APPLICATION

SEWAGE DISPOSAL TESTING

HOWARD COUNTY HEALTH DEPARTMENT
ENVIRONMENTAL HEALTH SERVICES

SUBDIVISION Highland Lake LOT NO. 109 # 107 86

SITE PLAN

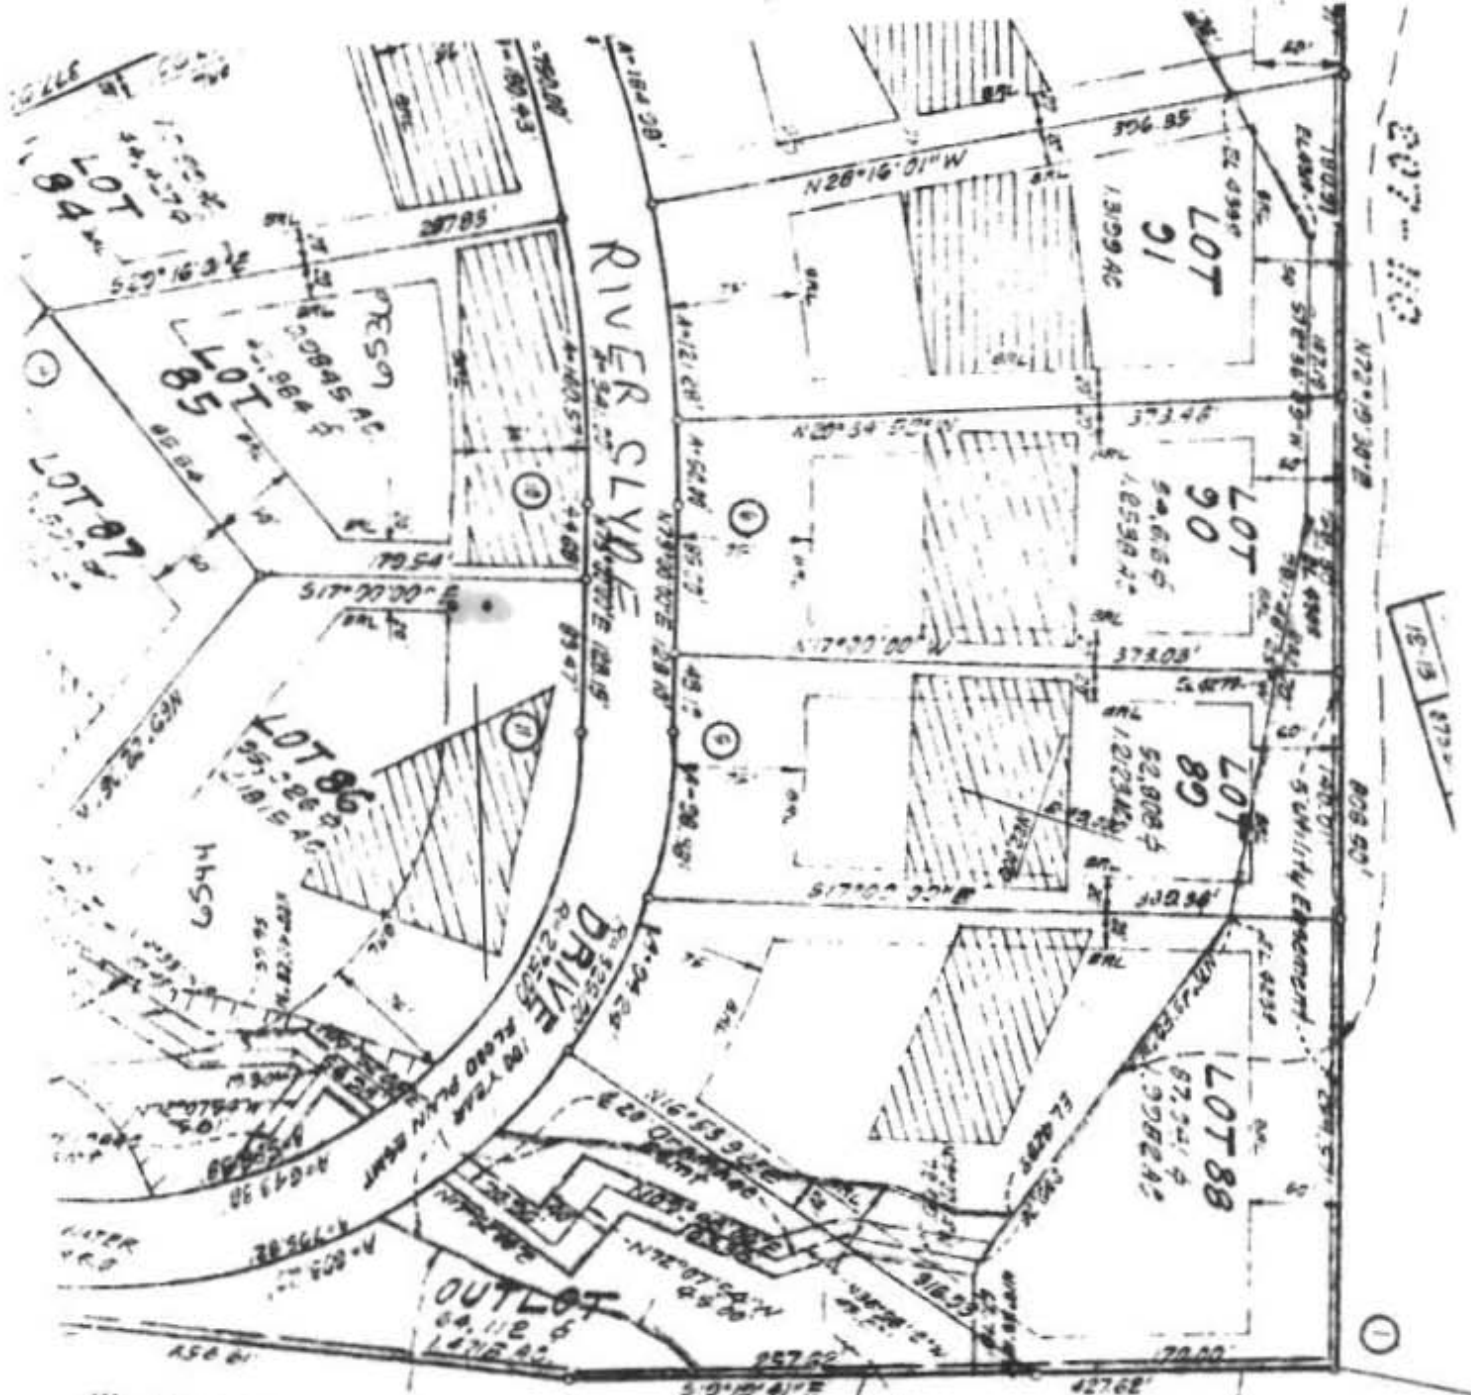
12/17/80
Sketch O.K.
J. S.

NOTE: NO PLUMBING IN BASEMENT

Drywell to have 120 SQ. FT. effective sidewall absorption area per bedroom below unit pipe. Drywell inlet at 3 ft. below original grade. Maximum depth of drywell is 9 ft. below original grade. Place the drywell 50 ft. from the front lot line and 60 ft. from the right side line as seen when facing the property from River Clyde Drive.
